AMENDMENT 82 TO POL CONSISTING OF CHANGES TO
TECHNICAL SPECIFICATIONS

COMMONWEALTH EDISON COMPANY

DOCKET NO. 50-237

PROVISIONAL OPERATING LICENSE

Figure 3.5-2 (Sheet 1 of 2)

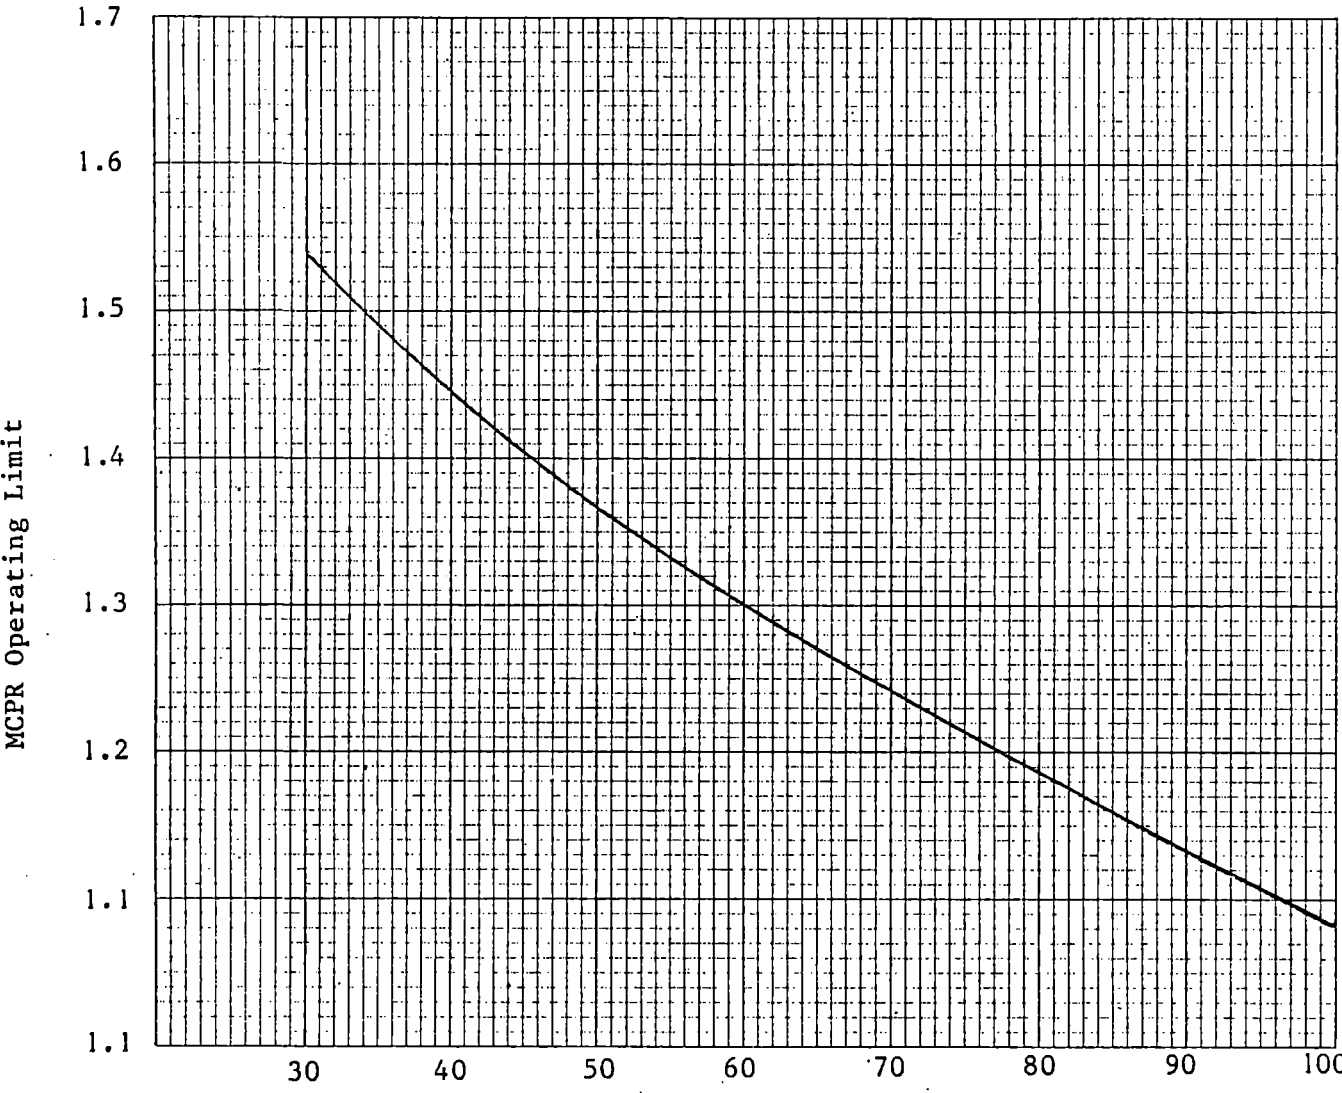
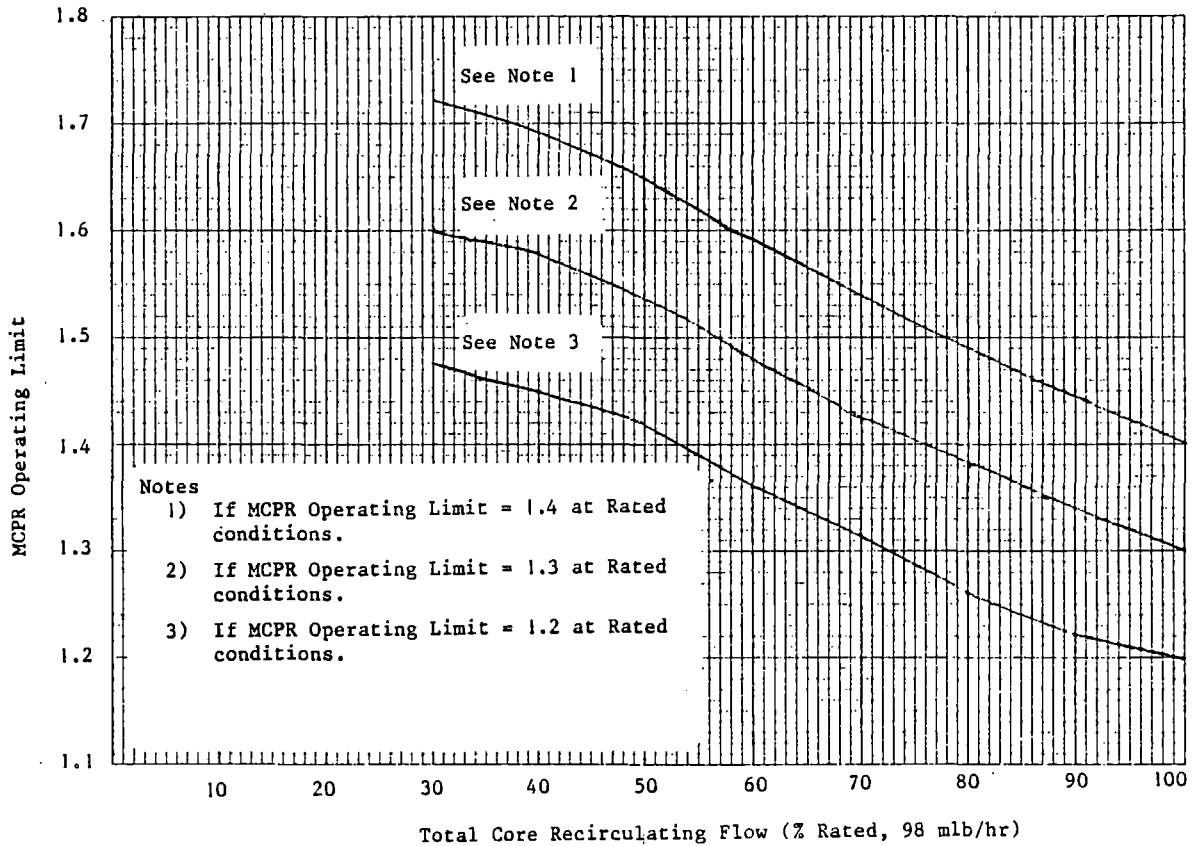
- M. 3. The MCPR Limiting Condition for Operation (LCO) will be increased 0.03 (TS 3.5.K and Fig. 3.5-2)
- 4. The Maximum Average Planar Linear Heat Generation Rate (MAPLHGR) limits will be reduced to 70% of current values for all fuel types.

- 3. The MCPR Limiting Condition for Operation (LCO) and Figure 3.5.2 will be increased 0.03 (TS 3.5.K)
